**ATTACHMENT 3
LICENSE AMENDMENT REQUEST
EXTENDED POWER UPRATE**

**RENEWED FACILITY OPERATING LICENSE
AND
TECHNICAL SPECIFICATIONS
MARKUPS AND CLEAN PAGES**

**FLORIDA POWER & LIGHT
ST. LUCIE UNIT 2**

**FIGURE 3.4-2
ST. LUCIE UNIT 2 REACTOR COOLANT SYSTEM PRESSURE-
TEMPERATURE LIMITS FOR 55 EFY, HEATUP, CORE CRITICAL, AND
INSERVICE TEST**

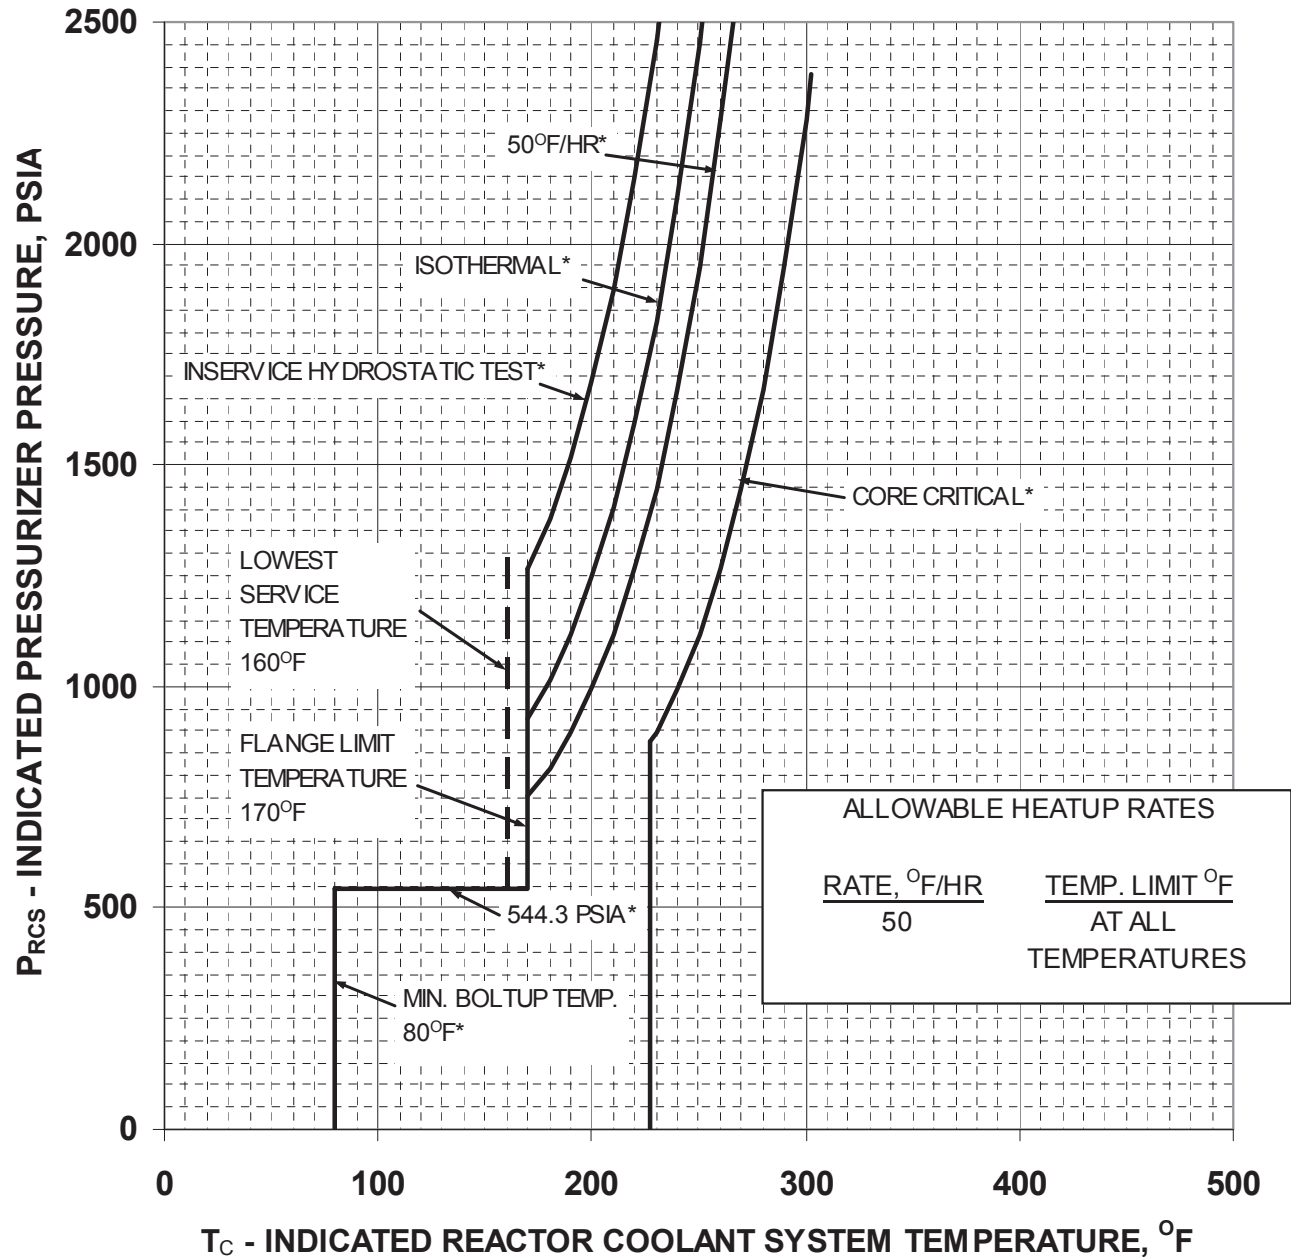
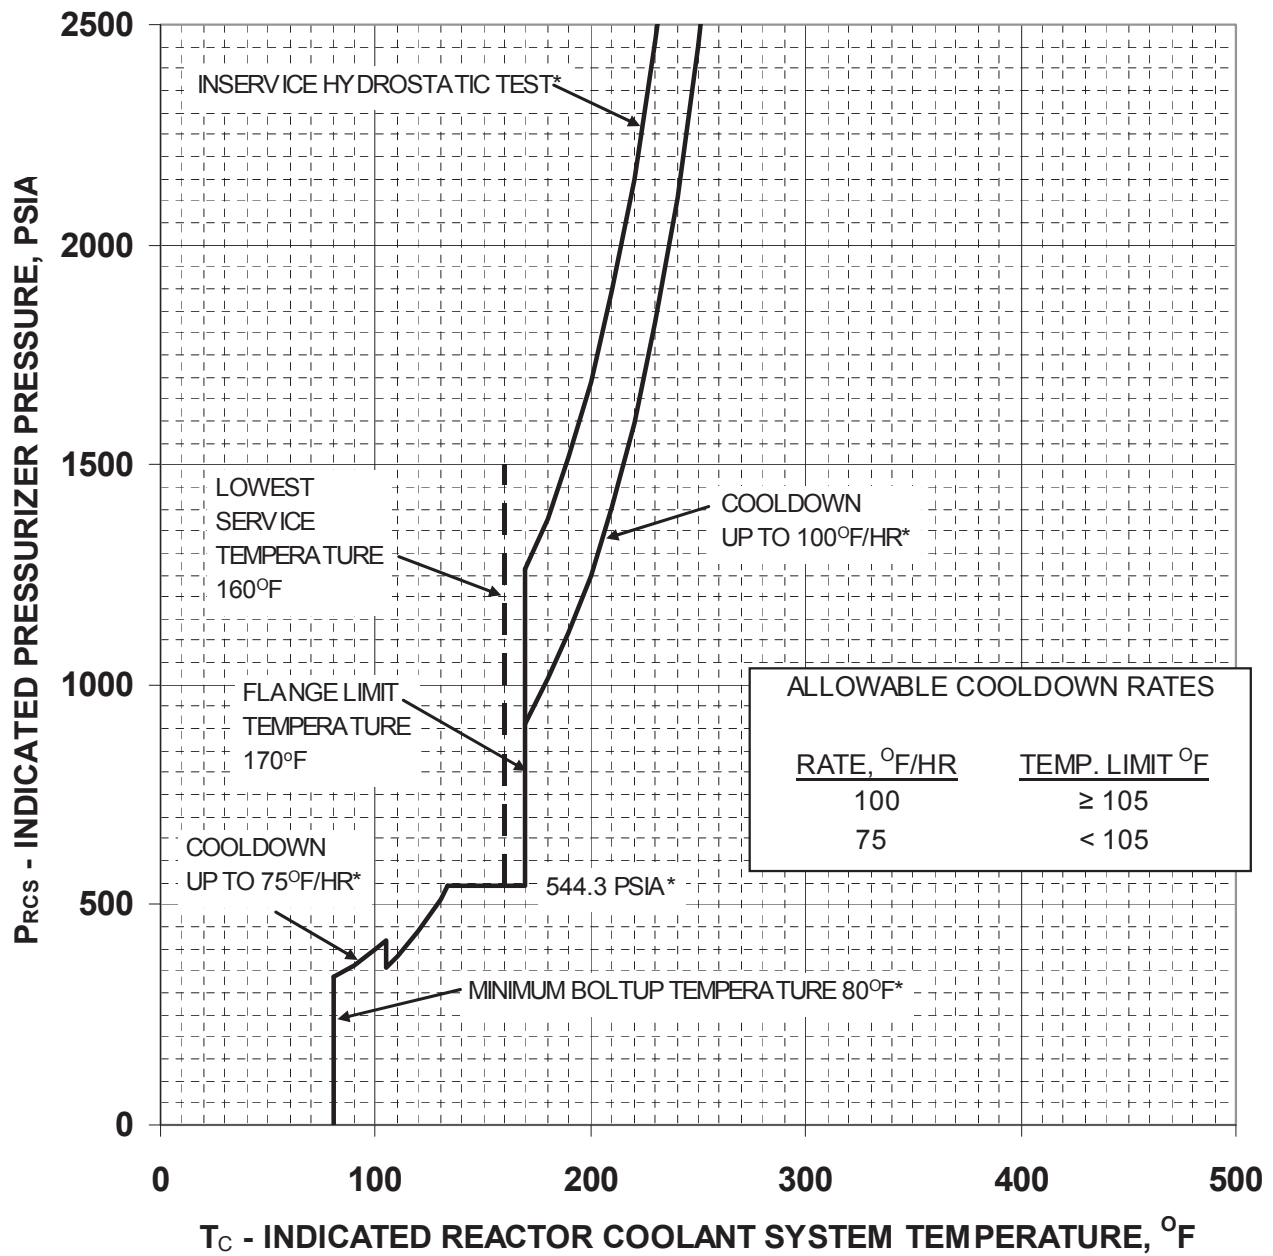
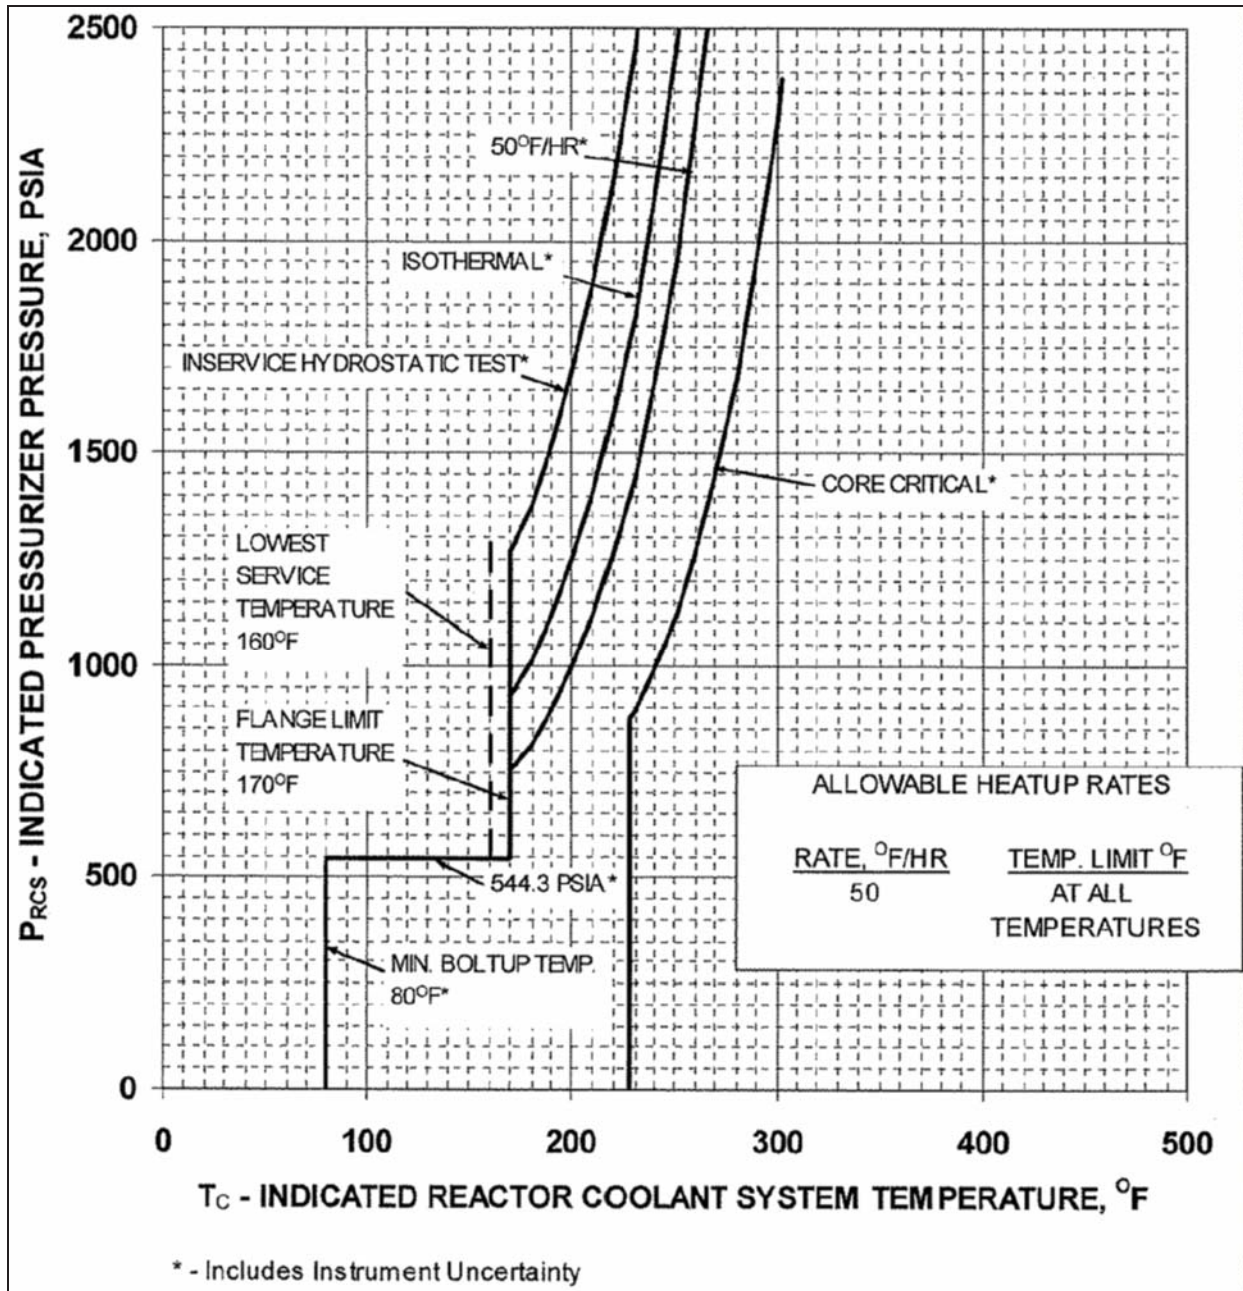
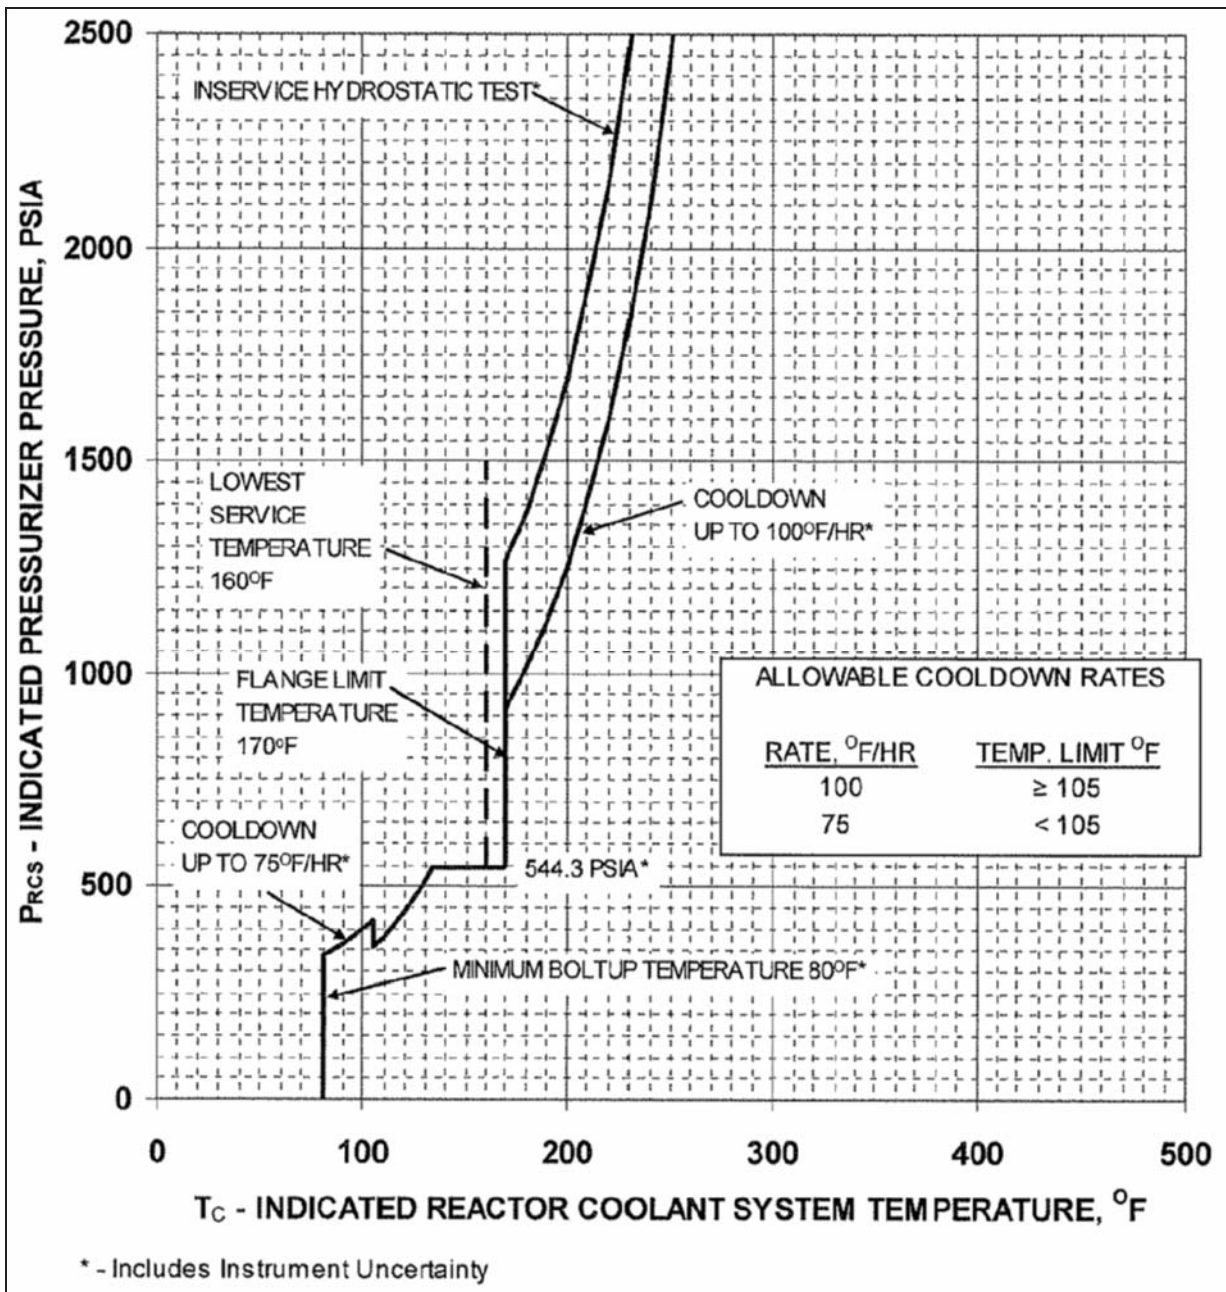
<u>FIGURE</u>		<u>PAGE</u>
3.4-3	ST. LUCIE UNIT 2 REACTOR COOLANT SYSTEM PRESSURE-TEMPERATURE LIMITS FOR 55 EFY, COOLDOWN AND INSERVICE TEST	3/4 4-31b
3.4-4	DELETED	3/4 4-32
4.7-1	SAMPLING PLAN FOR SNUBBER FUNCTIONAL TEST	3/4 7-25
5.1-1	SITE AREA MAP	5-2
5.6-1a	REQUIRED FUEL ASSEMBLY BURNUP vs INITIAL ENRICHMENT and DECAY TIME, REGION II, 1.3 w/o	5-4B
5.6-1b	REQUIRED FUEL ASSEMBLY BURNUP vs INITIAL ENRICHMENT and DECAY TIME, REGION II, 1.5 w/o	5-4C
5.6-1c	REQUIRED FUEL ASSEMBLY BURNUP vs INITIAL ENRICHMENT and DECAY TIME, REGION I, 1.4 w/o	5-4D
5.6-1d	REQUIRED FUEL ASSEMBLY BURNUP vs INITIAL ENRICHMENT and DECAY TIME, REGION I, 1.82 w/o	5-4E
5.6-1e	REQUIRED FUEL ASSEMBLY BURNUP vs INITIAL ENRICHMENT, REGION I, 2.82 w/o	5-4F
5.6-1f	REQUIRED FUEL ASSEMBLY BURNUP vs INITIAL ENRICHMENT, REGION II CASK PIT STORAGE RACK	5-4G
6.2-1	DELETED	6-3
6.2-2	DELETED	6-4

<u>FIGURE</u>	<u>PAGE</u>
3.4-3 ST. LUCIE UNIT 2 REACTOR COOLANT SYSTEM PRESSURE- TEMPERATURE LIMITS FOR 47 EFPY, COOLDOWN AND INSERVICE TEST	3/4 4-31b
3.4-4 DELETED	3/4 4-32
